WALL TYPE CLARIFICATION - BASEMENT

SINCLAIR PARK COMMUNITY CENTRE

WALL TYPE CLARIFICATION - ROOF

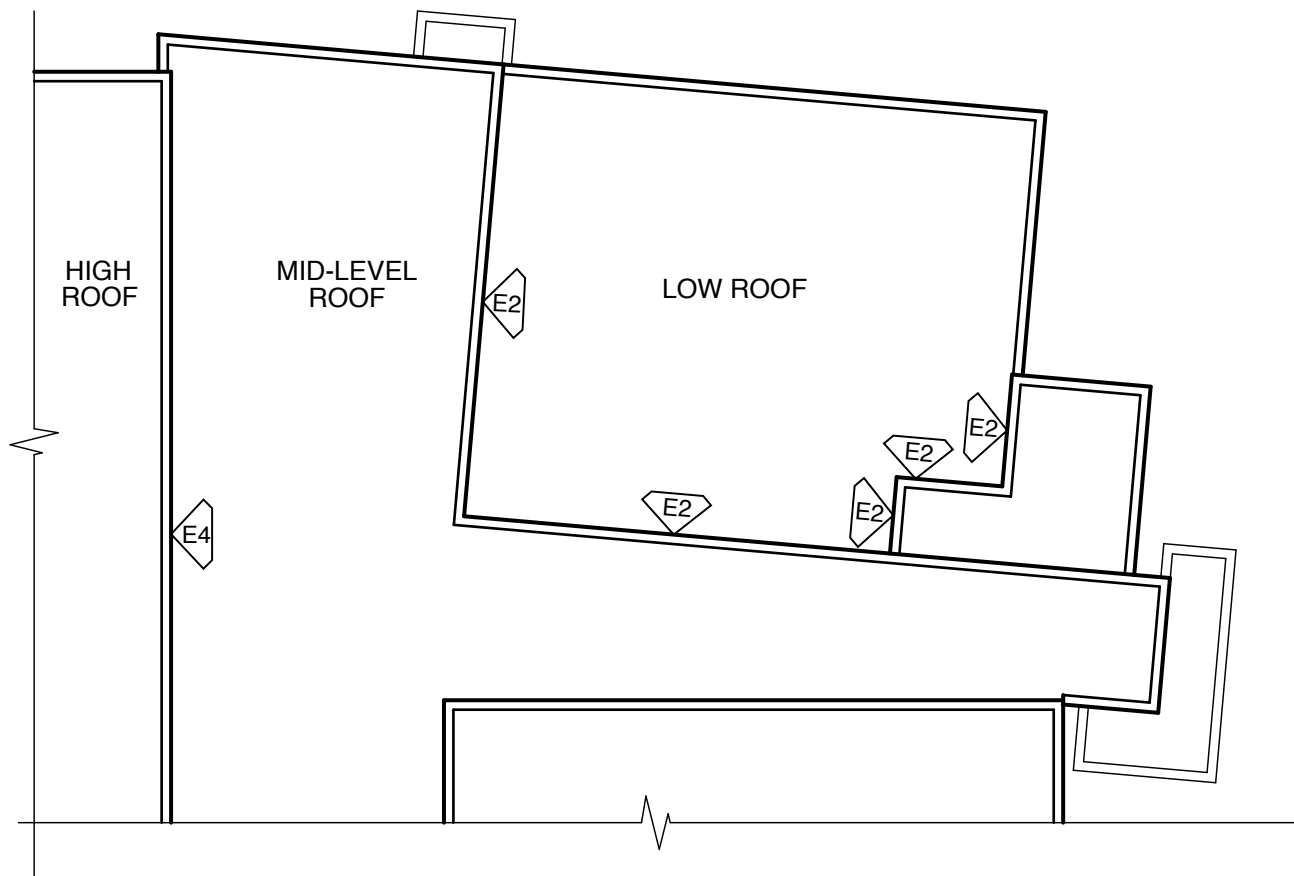
WALL TYPE REVISION:

- DELETE VHI GYPSUM FINISH NOT REQUIRED ON BASEMENT CONCRETE BLOCK WALLS.
